TECHNICAL SERVICE BULLETIN

74-A-3

OIL FILTER

1974 AUSTIN MARINA & MGB

DIAGRAM "A"

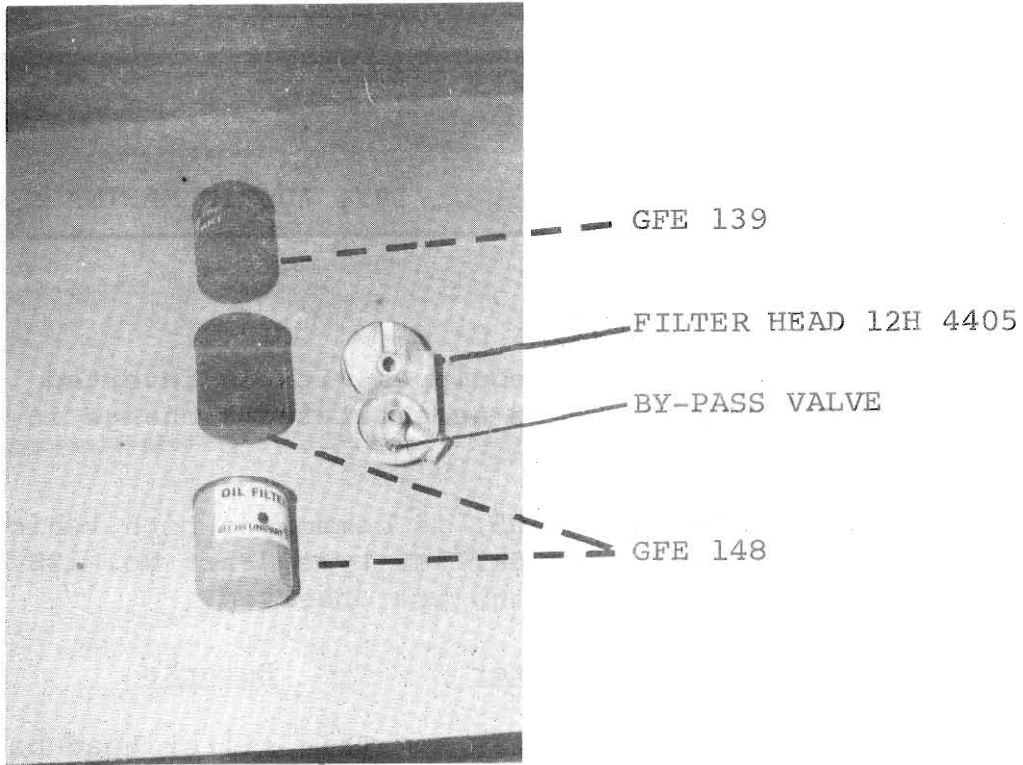
The 1974 Marina and MGB are now equipped with an inverted disposable-type oil filter, which necessitated a change in the filter head.

The filter head, Part No. 12H 4405, is common to both vehicles and is interchangeable with the earlier type, Part No. 12H 3273, providing the following precautions are observed.

<u>Filter Head</u>	<u>Use With Oil Filter</u>	<u>Remarks</u>
12H 4405	GFE 148 and GFE 139	This filter head has a built-in by-pass valve. (See Diagram "A")
12H 3273	GFE 114 <u>ONLY</u>	This filter head has <u>no</u> built-in by-pass valve, the valve being incorporated in the oil filter. (See Diagram "B")

You will note that on Filter Head Part No. 12H 4405 (Diagram "A"), the filter is installed to the underside of the filter head, whereas on Filter Head Part No. 12H 3273 (Diagram "B"), the filter is fitted on top of the filter head. Consequently, the latter type also incorporates an oil trap.
